Re: BusConnects Lucan to City Centre Core Bus Corridor Scheme
Lucan to Dublin City Centre

Here is the South Dublin County Council submission on the current Lucan to City Centre Core Bus Corridor SID Planning Application. Please acknowledge receipt of our submission by email.

Please note that on the attached GA drawing sheets there are notes (Yellow boxes) added and here is a summary of those notes in the Table below:

Programme Title: BUSCONNECTS DUBLIN CORE BUS CORRIDORS INFRASTRUCTURE WORKS			
Drawing Title: LUCAN TO CITY CENTRE CORE BUS CORRIDOR SCHEME GENERAL ARRANGEMENT			
Drawing File Name: BCIDA-ACM-GEO_GA-0006_XX_00-DR-CR-0012	Sheet Number: 12 of 31	Status: A	Rev: M01

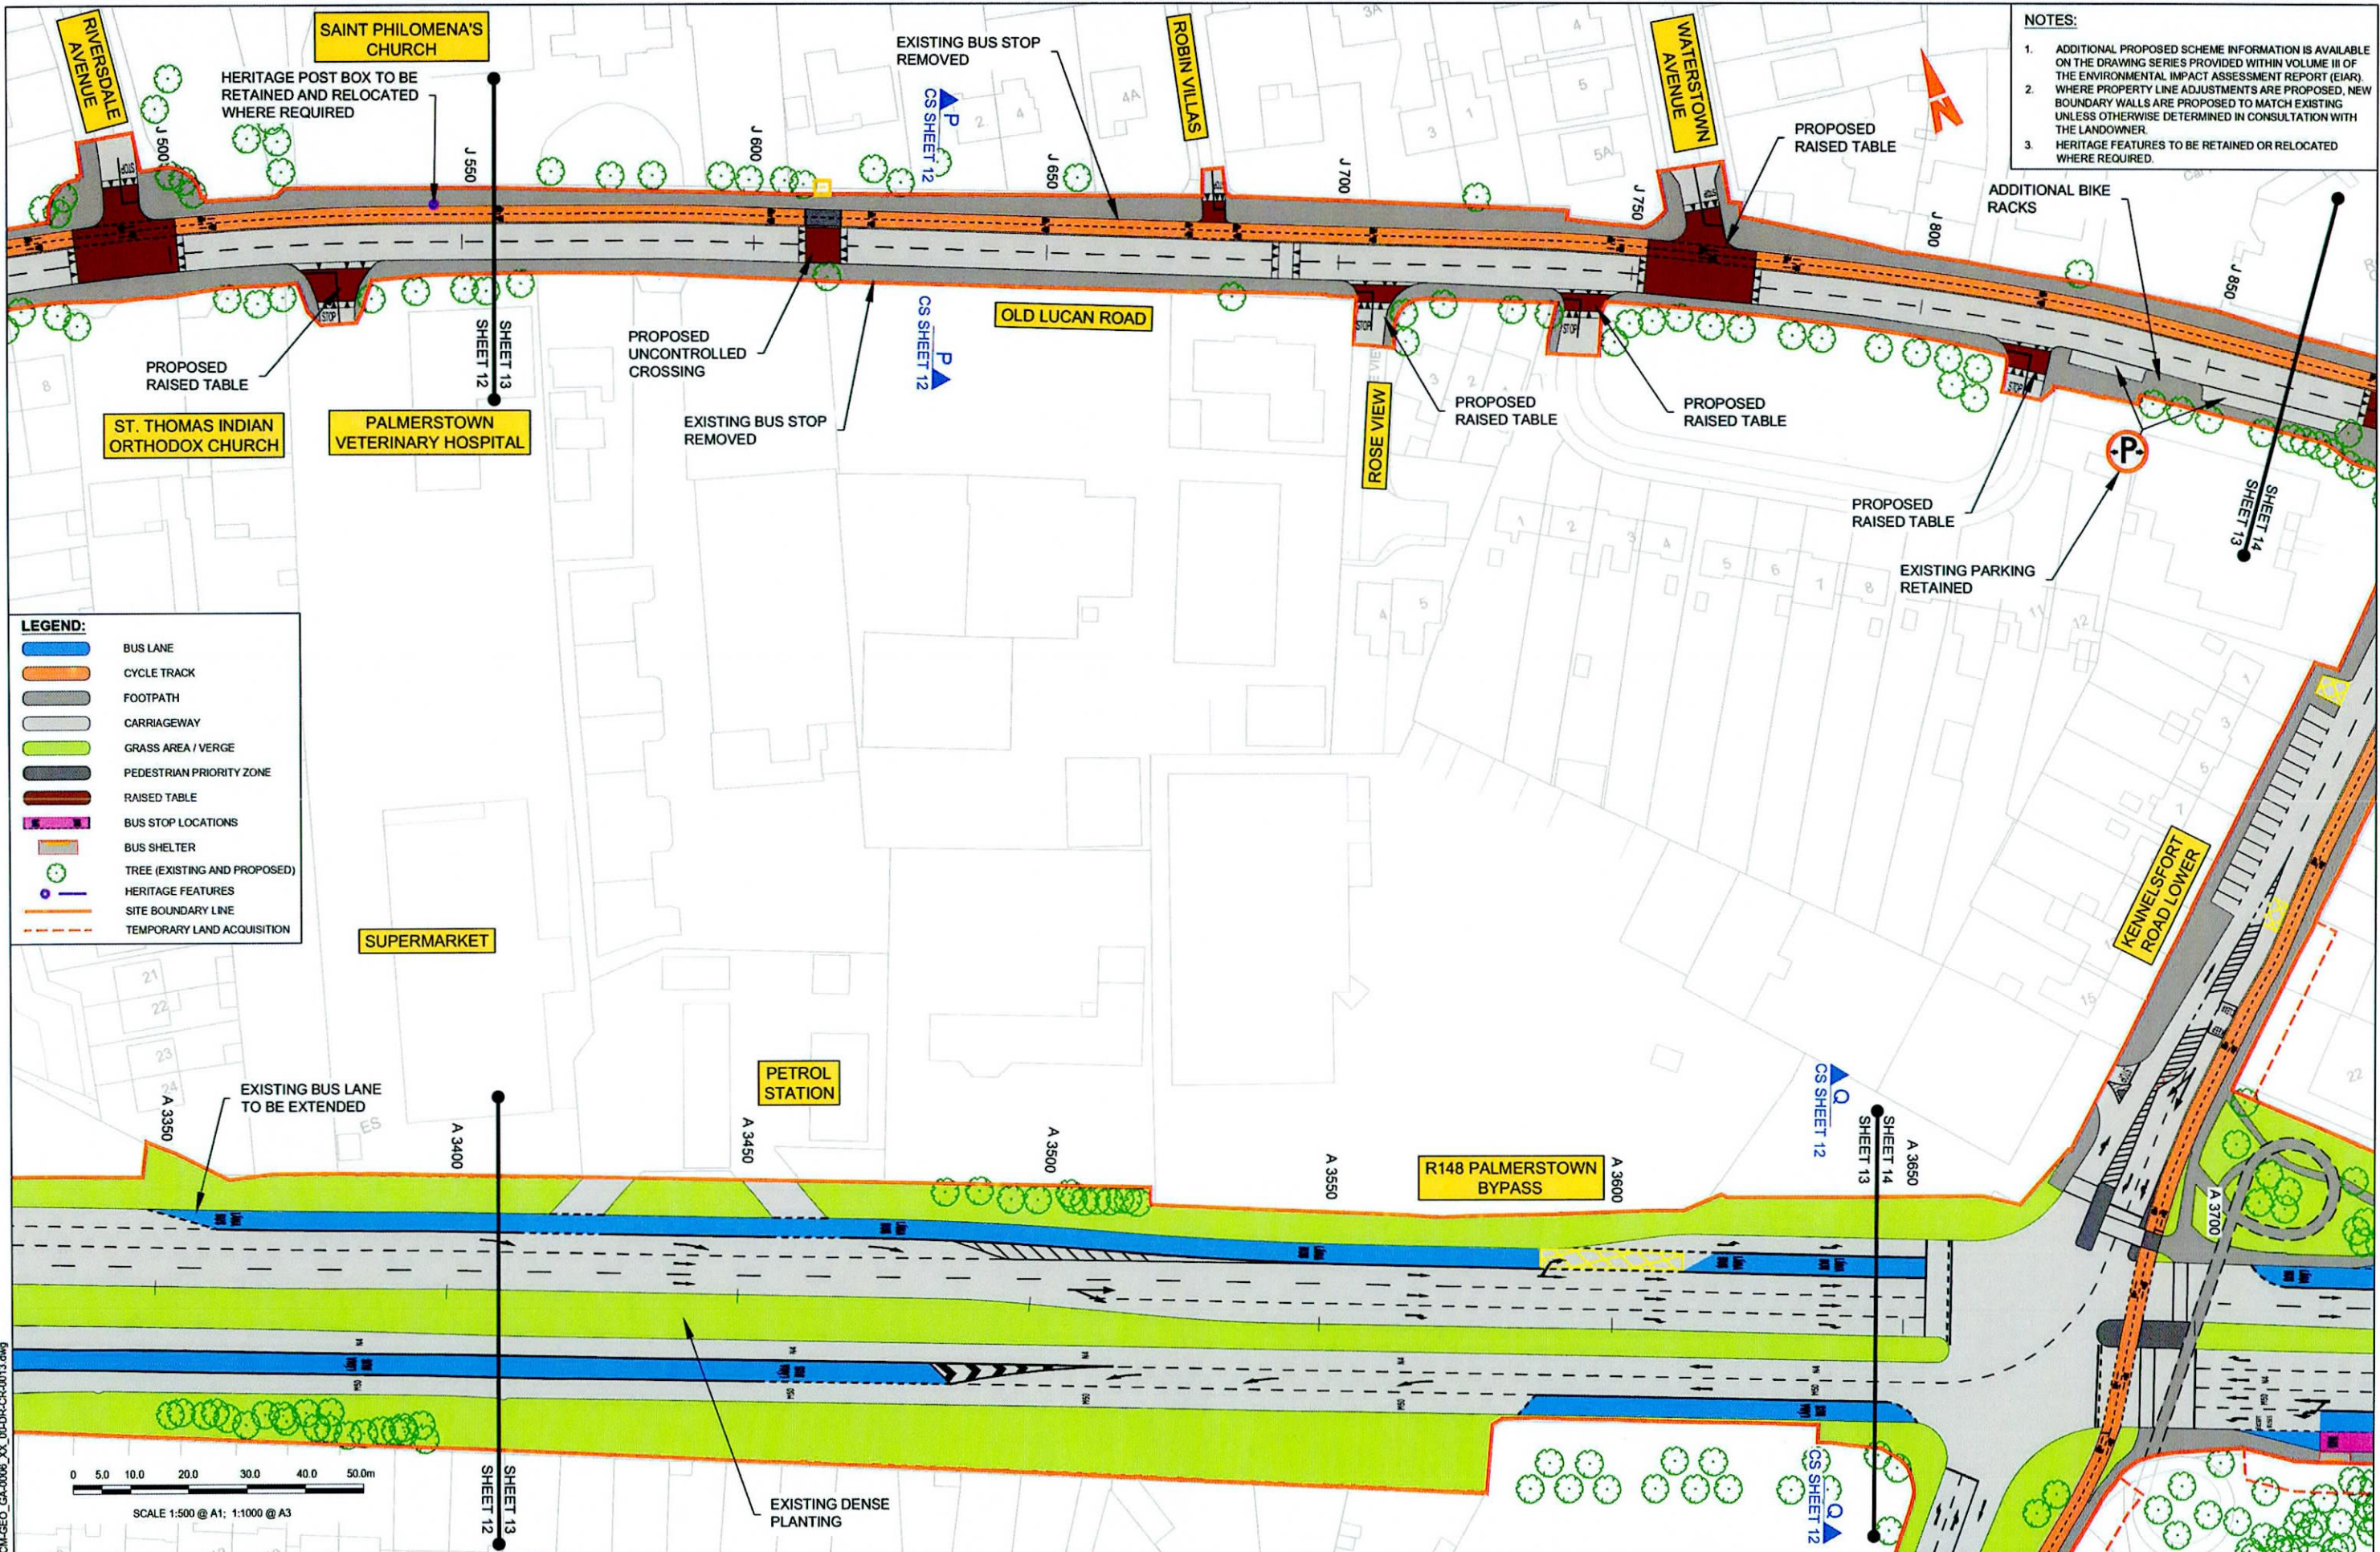
AT 38	Sheet 11	CH I 750	Existing cycle track to cross M50	Is cycle track wide enough?
AT 39	Sheet 12	CH J 300	Old Lucan Road and Hollyville Lawn	Can radius be tightened? If stop line is at road edge, who has priority?
AT 40	Sheet 13	CH J 600	Old Lucan Road	Cycle track white line should break at crossing.
AT 41	Sheet 14	CH K 0	Junction of Old Lucan Road and Kennelsfort Road Lwr	See previous note re: left to go right
AT 42	Sheet 14	CH K 150	Junction of Old Lucan Road and Mill Lane	Significant sweep from kerb end to entrance.
AT 43	Sheet 15	CH K 275	Old Lucan Road to The Oval	If this footpath is to serve as a shared path to link The Oval to the two way, it needs to be significantly wider. Could the western footpath be removed and the traffic lanes shifted west? Or the path widened into the green area.

Programme Title BUSCONNECTS DUBLIN CORE BUS CORRIDORS INFRASTRUCTURE WORKS			
Drawing Title LUCAN TO CITY CENTRE CORE BUS CORRIDOR SCHEME GENERAL ARRANGEMENT			
Drawing File Name	Sheet Number	Status	Rev
BCIDA-ACM-GEO_GA-0006_XX_00-DR-CR-0015	15 of 31	A	M01

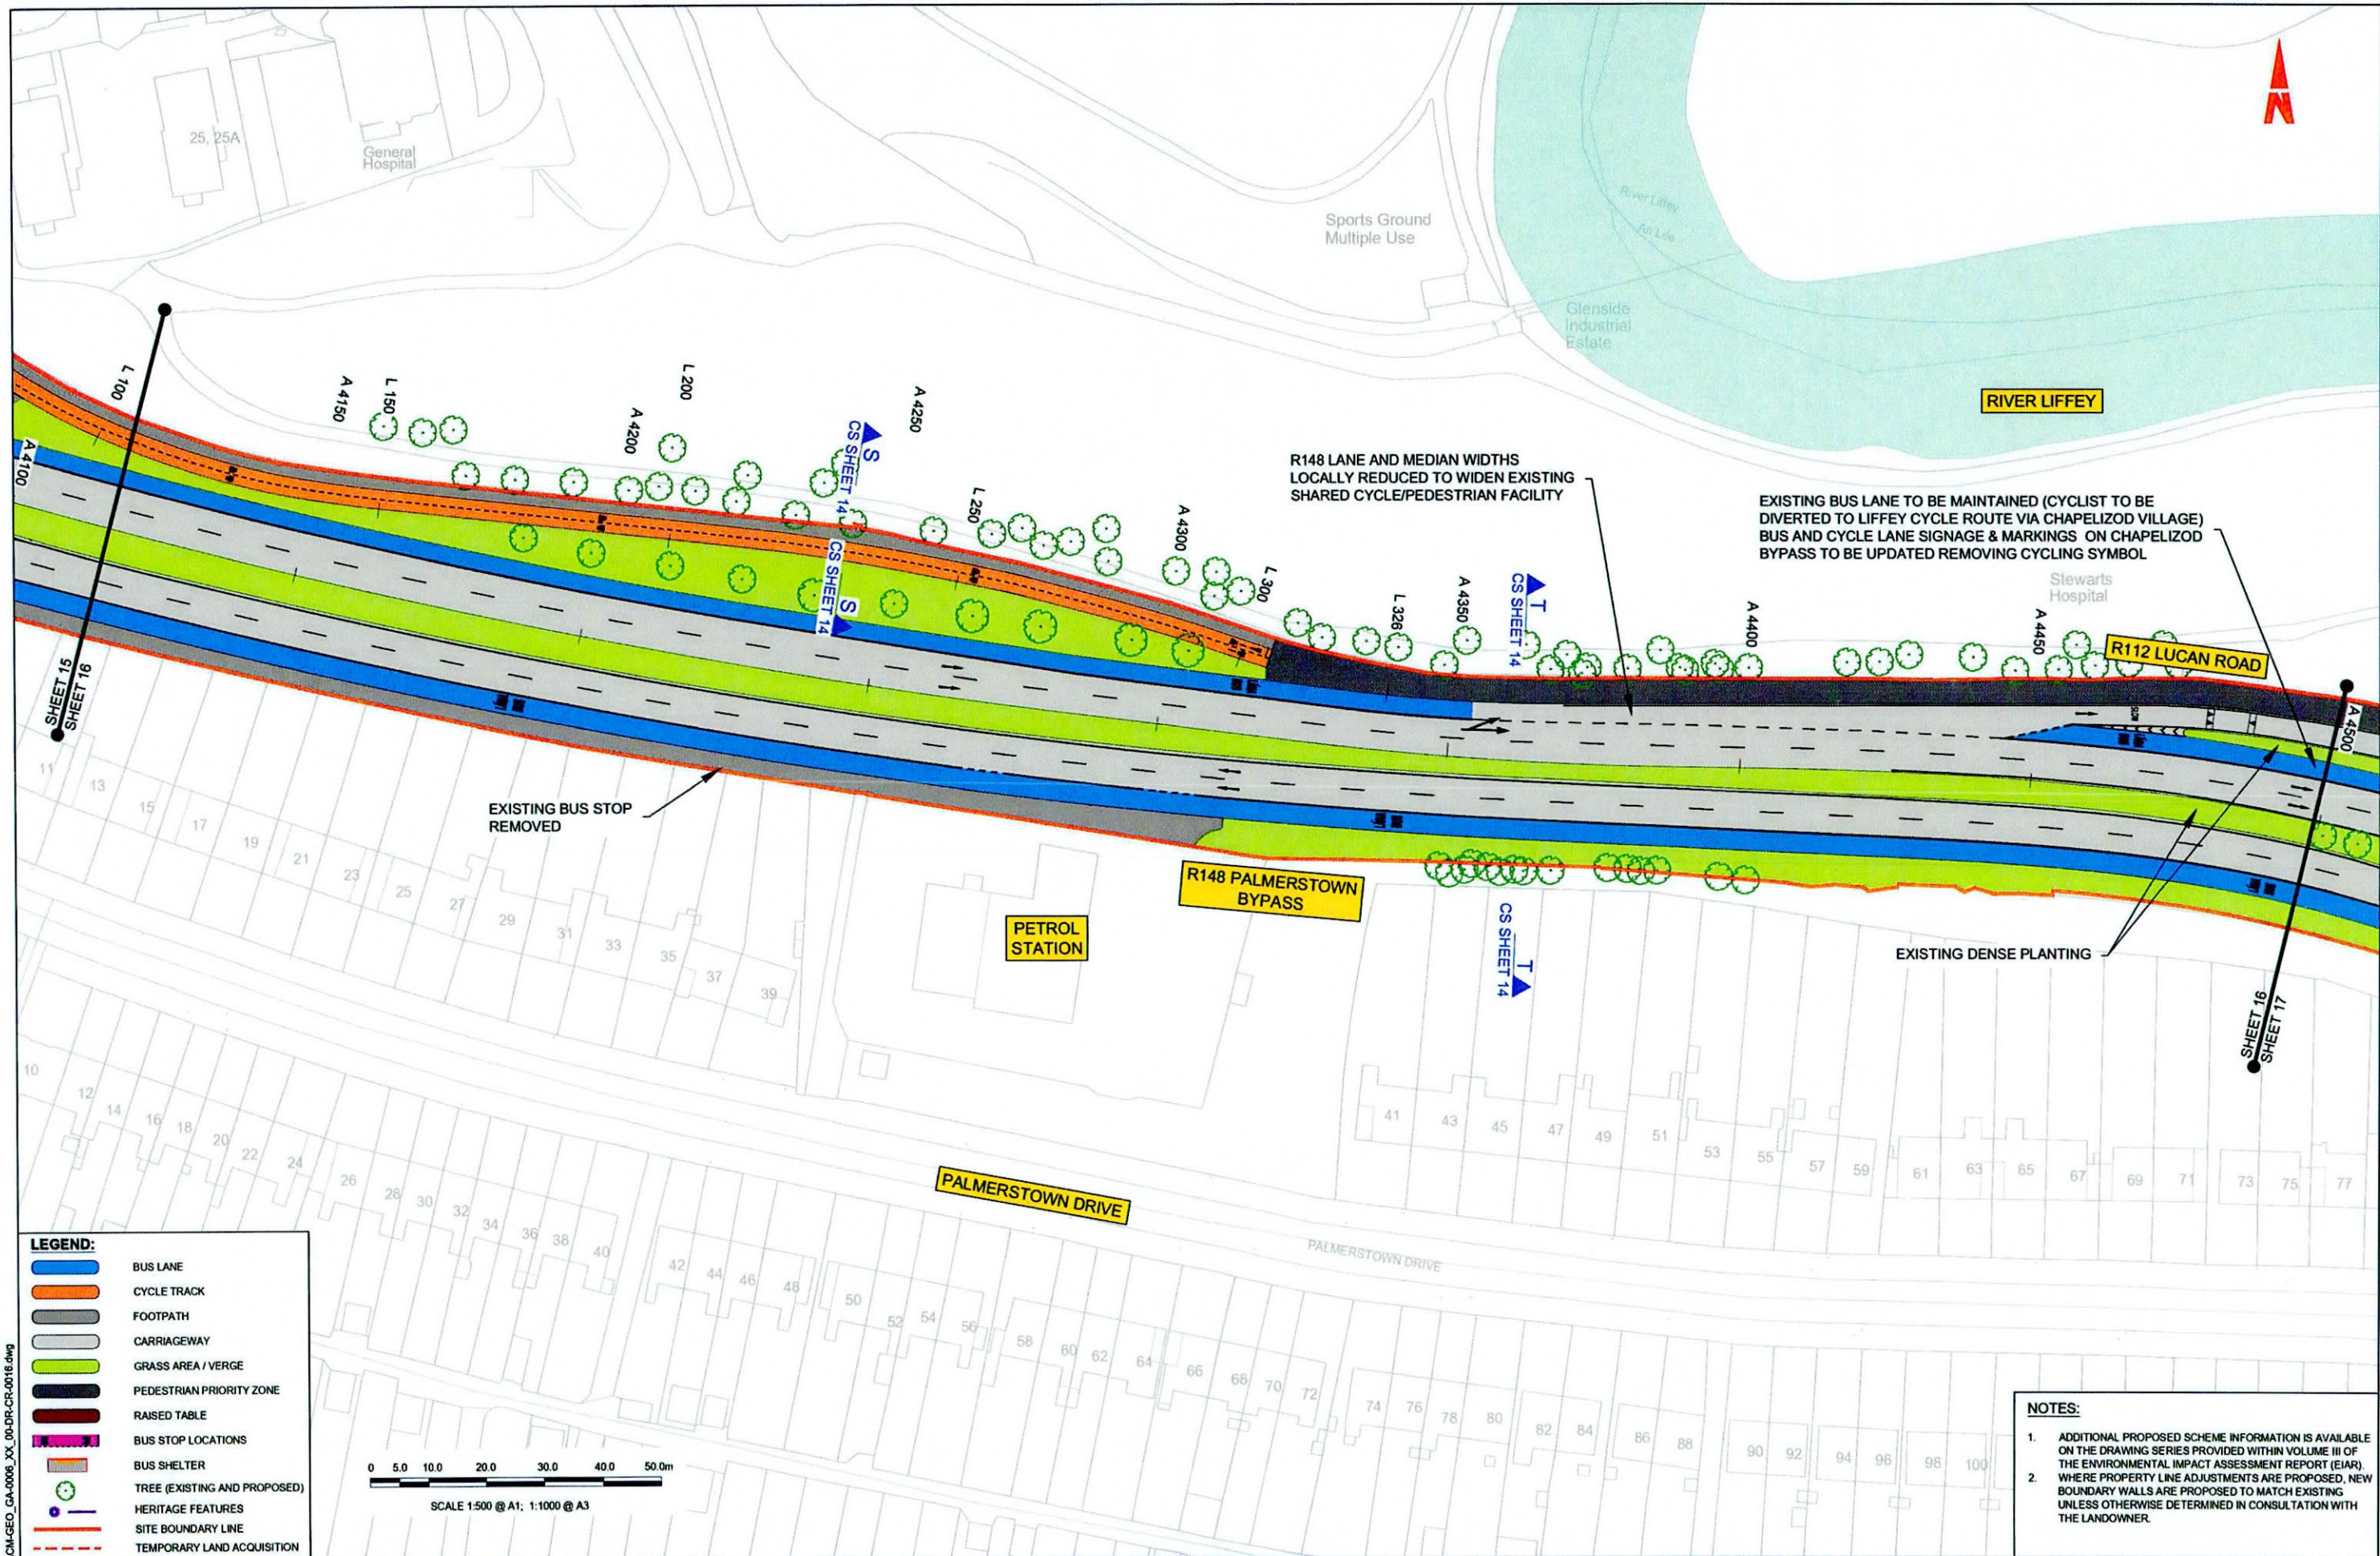
Can right left and straight ahead be from a single lane?
AT 44	Sheet 15	CH L 50	Cycle track at end of Old Lucan Road	Is this an operating entrance? Can it be removed / the footpath continue through?
